Integrated Device Technology, Inc.
2975 Stender Way, Santa Clara, CA - 95054

PRODUCT/PROCESS CHANGE NOTICE (PCN)

PCN #: **A-0412-04** DATE: 12/15/2004

Product Affected: All Green Products

Before Change (example)

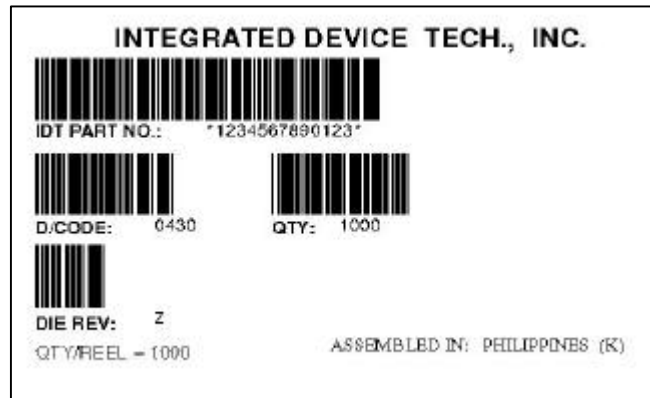
Add Pb-free words, category and maximum safe operating temperature to IDT standard bar code label.

After Change (example)

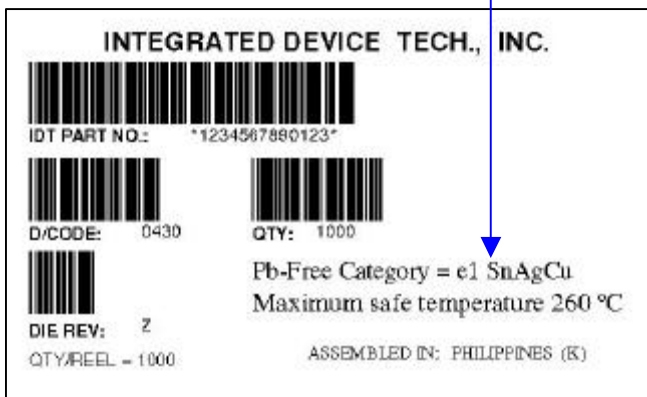
Pb-free category = e1 SnAgCu (BGA packages)
and maximum safe temperature

Attachment 2: (Customer specific)

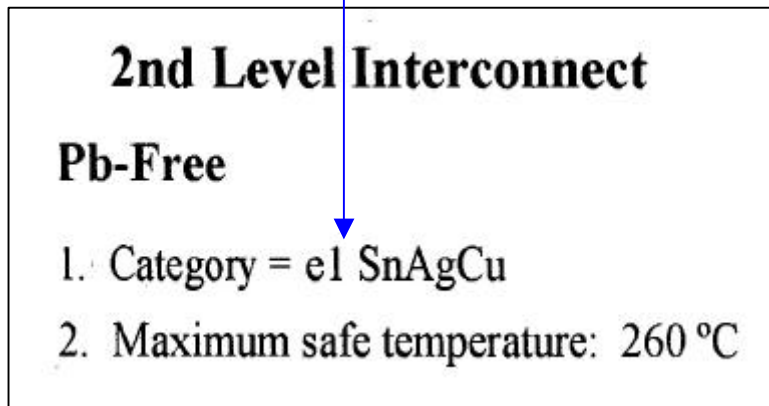
Add an additional 2nd Level Interconnect label consisting of Pb-free words, category and maximum safe operating temperature.

Category = e1 SnAgCu (BGA packages)

Category = e3 Sn (lead frame packages)
